Ref: Planning Application DM/23/0550
Proposed Loft Conversion, Dormer Roof Extension To Fen Place
Bungalow, East Street, Turners Hill RH10 4QA

Plan A

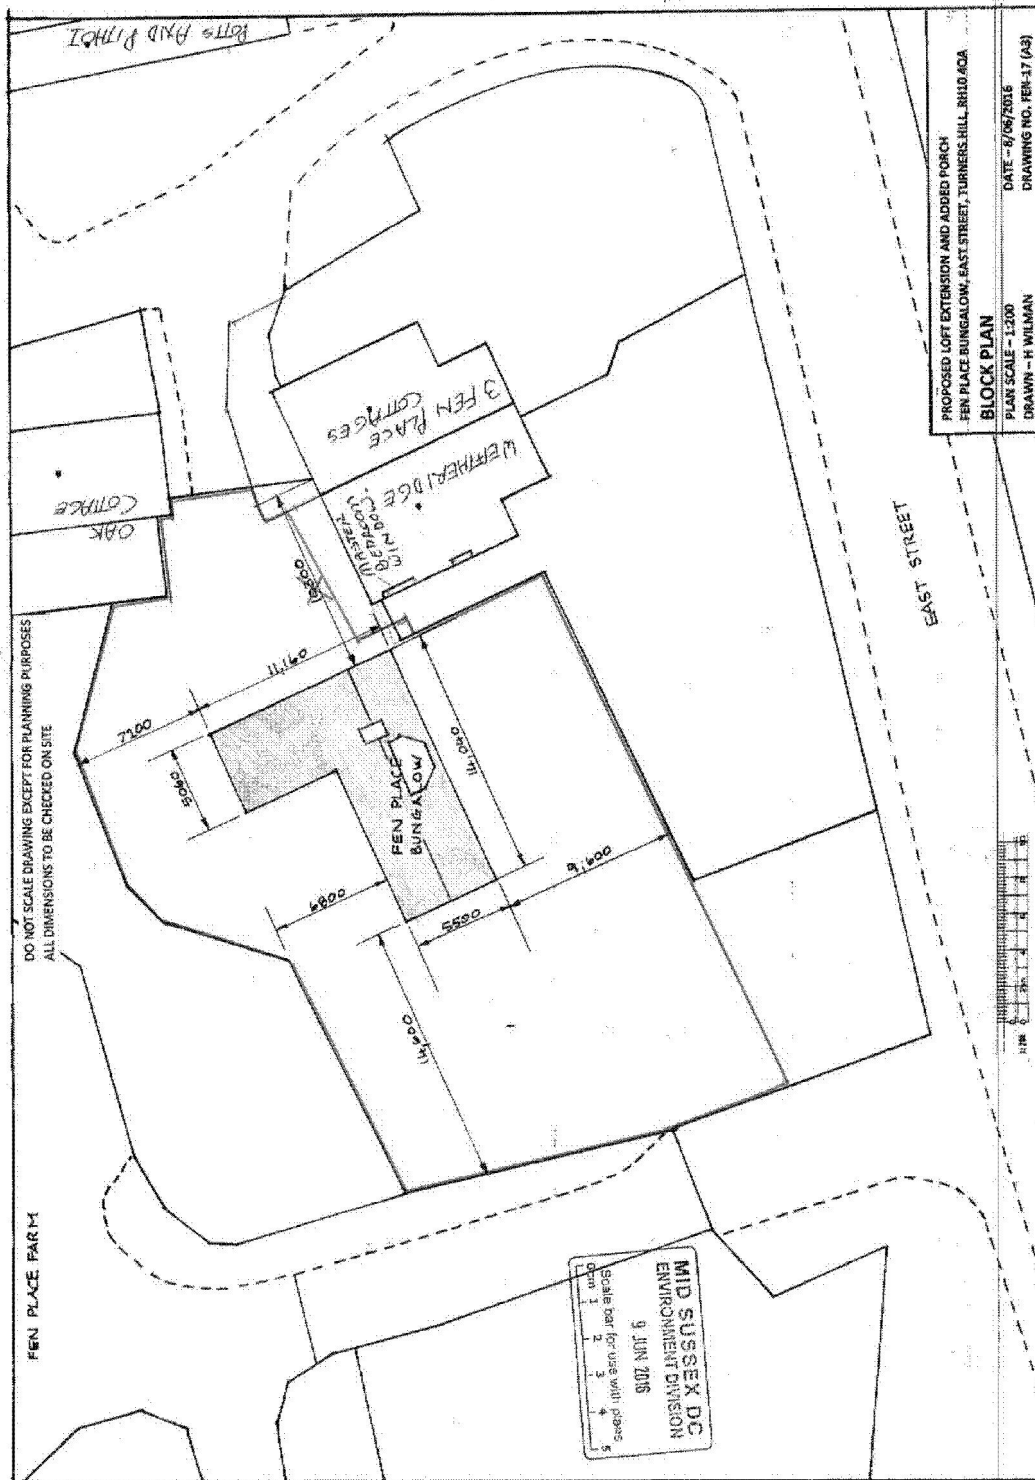
I do want to specifically point out that the land ownership of Fen Place Bungalow shown on Location Plan and Site Block Plan and Block Plan Drawing No WPD5922/A/02 is incorrect. The actual property boundaries are shown in red on attached Plan A. I do not expect any of the red line boundary to encroach onto my property or right of access.
